**Safety Evaluation Report, Revision 1, of License Amendment Request, dated September 24, 2018, United Nuclear Corporation (UNC) submitted a request to the U.S. Nuclear Regulatory Commission (NRC) to amend its Source Materials License No. SUA-1475 for the former UNC Church Rock uranium mill and tailings site under the requirements specified in Title 10 of the *Code of Federal Regulations* (10 CFR), Part 40, Domestic Licensing of Source Material**

Materials License No. SUA-1475

Docket No. 040-08907

**United Nuclear Corporation**

**Figure 5:** Proposed profile of the future repository and disposal cell in a borrow pit area.

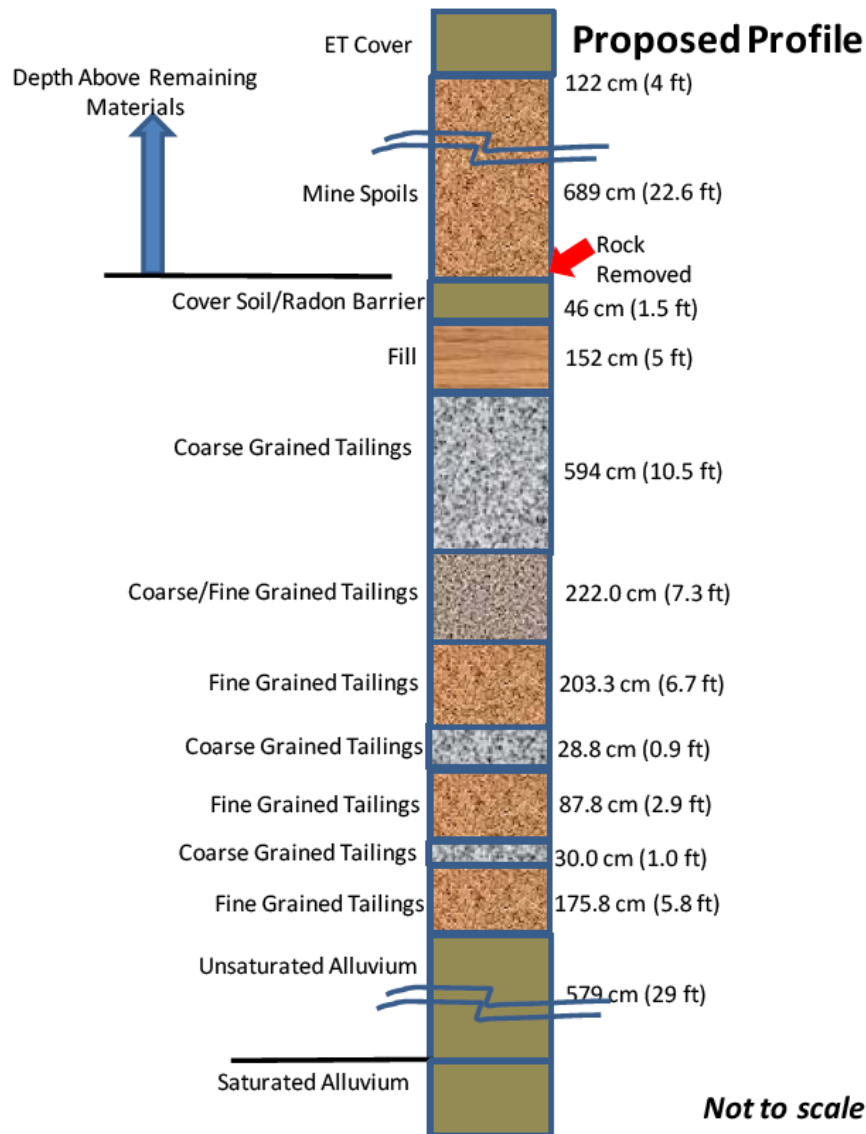
Appendix Y (UNC, 2020e) of the LAR contains the results of the licensee's analysis of the potential effect of the added weight of the mine waste on the underlying mill tailings and subsequently on the underlying groundwater. Mine waste will be disposed of in a repository designed within the footprint of the existing tailings impoundment at the mill site. Rocks and riprap on top of the current cover at the Church Rock site will be removed before placement of the mine waste and later reused at the surface. The original disposal cells with tailings will not be altered and the original radon barrier will also be left in place. Figure 5 shows a profile of the future repository and disposal cell in a borrow pit area (borrow pit 1). Placement of the mine spoils and subsequent ET cover components will place added weight, and thus stress, on the existing tailings material originally placed within the existing impoundment. Appendix Y states that there is a relatively small reduction in porosity in the tailings due to the added weight on the existing impoundment and that the coarse and fine tailings become fully saturated in some of the profiles. However, the licensee states there is no increase in flux into the underlying groundwater from the tailings and therefore no drainage impact into the underlying groundwater. Similar to the UNSAT-H simulation results performed in Appendix G, Attachment G.7, findings from these sensitivity analyses show that the new ET cover components prevent flux while the existing cover did allow percolation into the disposal cell, but no downward flux from the base of the alluvium.

However, the revised ET cover layers now has a total thickness of 4.5 feet (UNC, 2019d). [Source: Modified Figure of Figure 10 from Appendix Y of the LAR (UNC, 2020e)]

**Figure 10:** PMP temporal accumulations for various durations

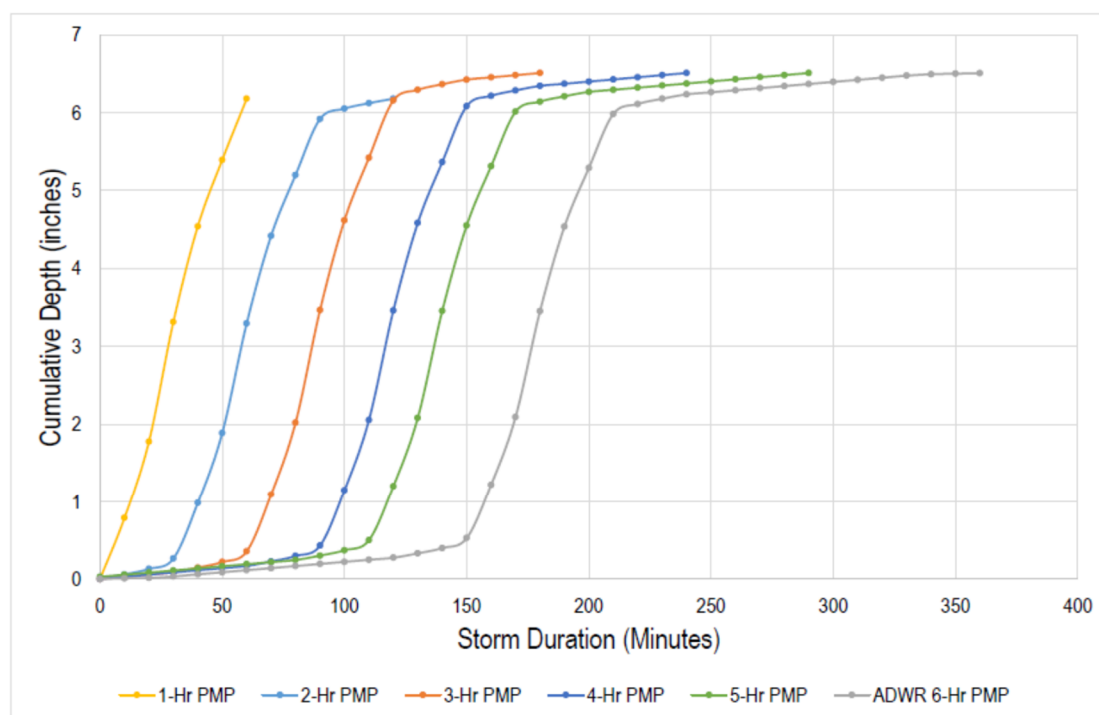
As presented in Figure 10 below, the licensee's intensity-ratio method is to distribute a 1-hour peak precipitation at the middle of temporal distribution of other PMP events as the same pattern of the 1-hour peak precipitation within the 6-hour PMP event.

**Figure 11:** Location of the proposed riprap chute in the Pipeline Arroyo and the existing Branch Swale H and two evaporation ponds

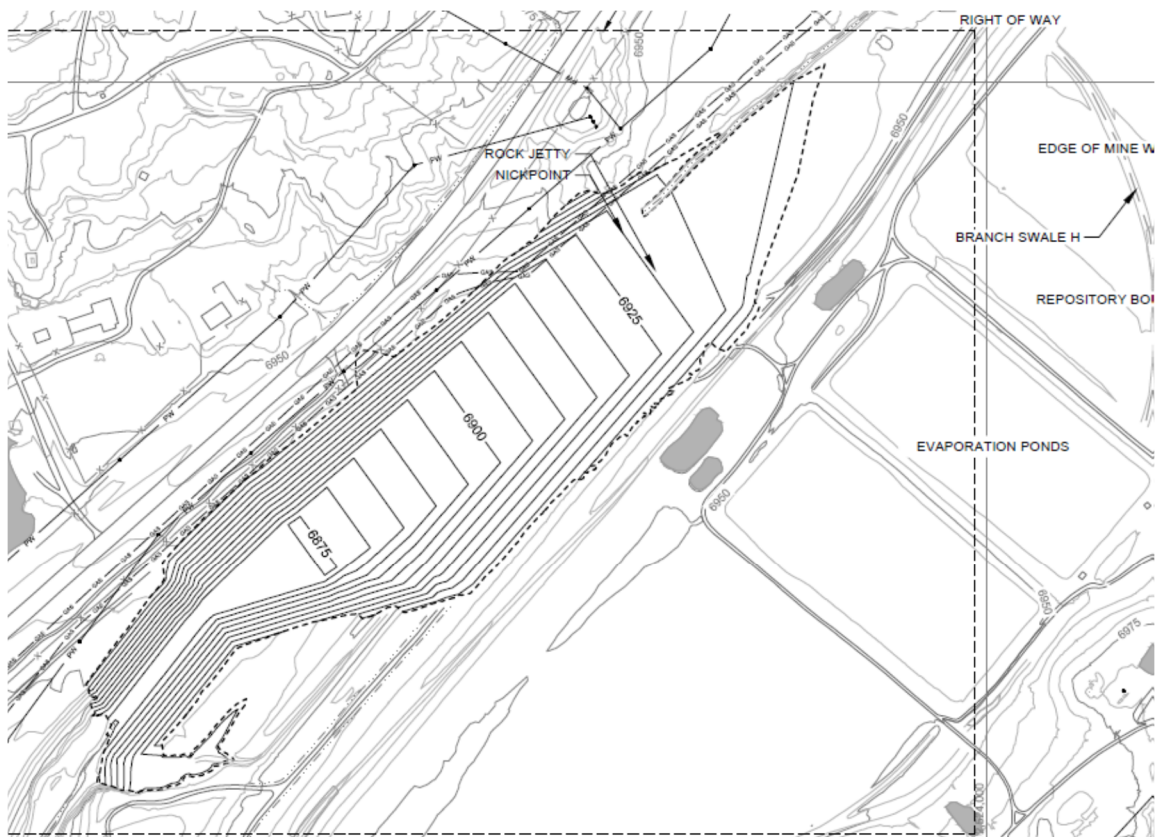
The licensee used a three-dimensional model to simulate steady flow conditions within the riprap rock chute and the sunken basin for multiple flood events. The simulation results indicate that the PMF produces a maximum flow speed of 27 ft/s near the right bank (northern side) of the riprap chute (Figure 3 of Supplement I.7.1 of Attachment I.7 of Appendix I, Volume I). The licensee used this flow velocity as a main velocity to design the riprap rock protection for the chute and the sunken basin. The licensee selected other velocities lower than 27 ft/s as secondary options to design riprap rock protection for low flow velocity areas.

During its review, the NRC staff evaluated several different aspects of UNC's design, including: (1) the variation in the depth-average velocity along the cross section given the approximately uniform flow depth indicated on Figures 2 and 3 of Attachment I.7; (2) the channel roughness using a 12-inch height; (3) observed high flow velocities larger than 3 ft/s (Figures 2 and 3; Design Drawing 09-10) in some local areas without riprap rock protections; (4) the length of the hydraulic jump at the bottom of the riprap chute; (5) balancing of sediment transport between the inlet and outlet of the designed basin; and (6) mesh size in the 3D model. The licensee's approach to each of these aspects of the design and the NRC staff's conclusion is summarized below (the licensee's approach is summarized from UNC, 2019b).

*In design drawings 9-09, 9-10, and 9-11, Stantec extended the apron length to the riprap basin to 380 feet. This is sufficient to provide erosion protection beyond the length of the hydraulic jump. The revised drawings are included as Attachment 3 to this submittal.*

**Figure 12:** Layout of drainage system in the proposed repository area of the mill site

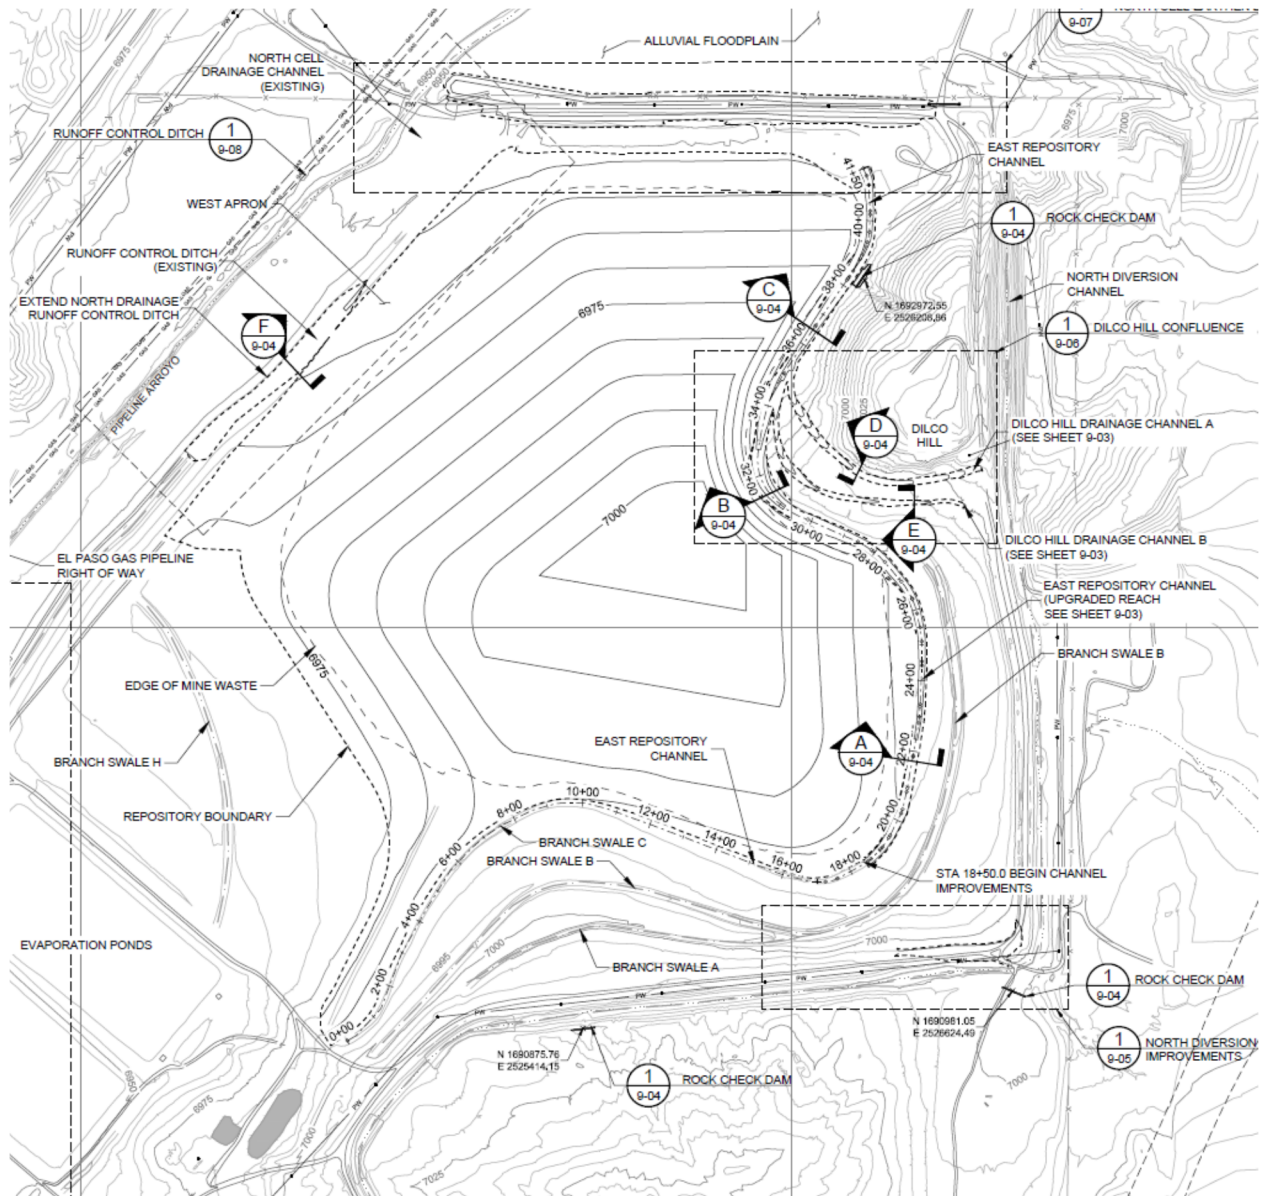
The licensee proposed the lower East Repository Channel and two branches, Dilco Hill Channels A and B, to convey surface runoff from the Church Rock Mill Site Repository and Dilco Hill areas to the existing North Cell Drainage Channel (see Figure 12 below).

The repository area will be overlaid by a proposed mine waste layer and a cover layer as part of the Removal Action (RA) plan. The proposed lower East Repository Channel will follow the existing path of the upper reach of the North Cell Drainage Channel. The licensee presented the channel alignment, channel profiles, and typical channel cross sections in the Design Drawings 9-02 through 9-06 (Volume II Design Drawings of the LAR,) for the lower East Repository Channel and the two Dilco Hill Channels A and B. The Design Drawing 9-02 also shows the locations of Branch Swale H, which has no outlet (see middle left edge of Figure 12), and Runoff Control Ditch, which connects to a natural drainage downstream along the northwest edge of the mill site repository area.
